HEAT PUMP INSTALLATION UPDATE

Say hello to easier installation
with a supplied power cord.

From July 2026, a 15A
plug & play unit with 3m cord is supplied.

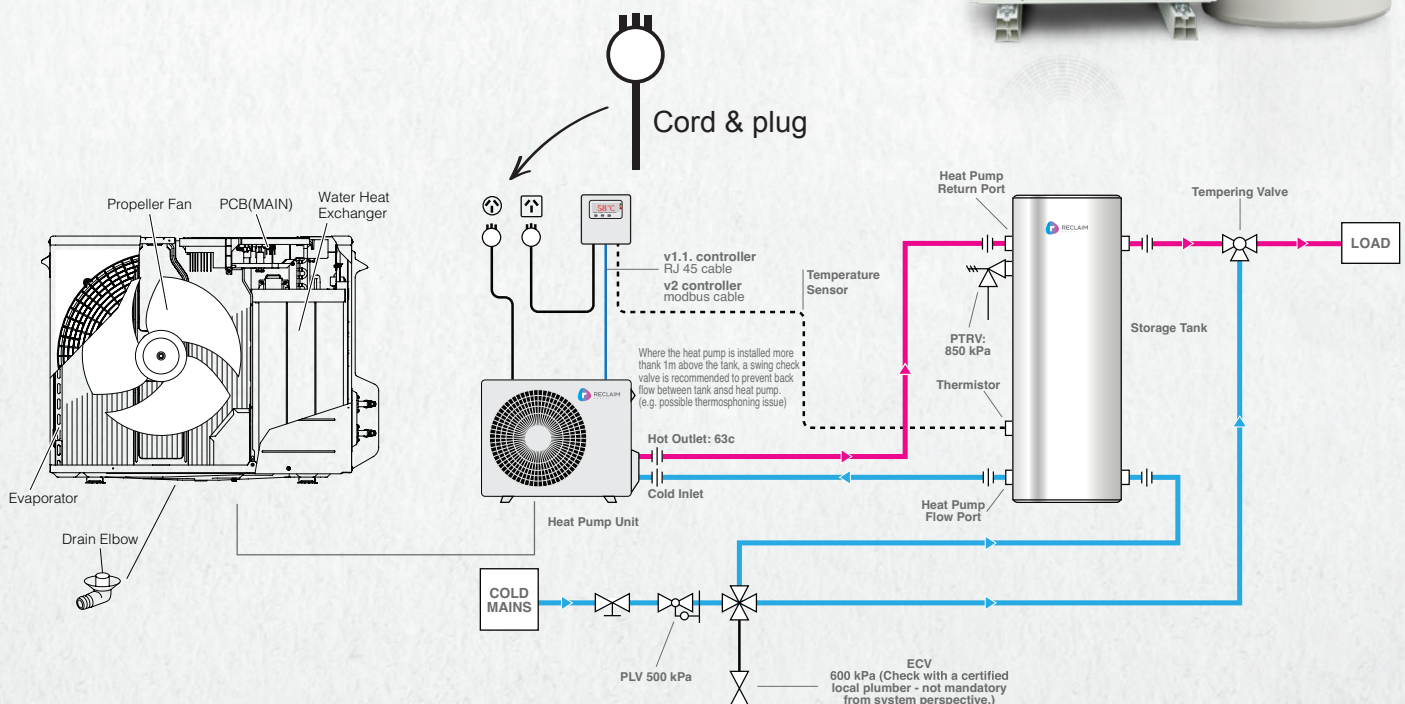
Old

Heat pump required hard wiring
by the installer on site.

Electrical connection was made
directly to an isolator switch.

New

A 3 metre power cord & 15A
plug are now supplied with
the heat pump.

Hard-wired connection → Supplied 3m power cord & 15A plug.

Dedicated 15A circuit + compliant isolation requirements.

The heat pump must be connected to a dedicated 15A electrical circuit.
Installation must comply with all applicable Australian Standards and local electrical regulations.

An approved method of electrical isolation must still be provided in accordance with relevant Australian Standards and site requirements.
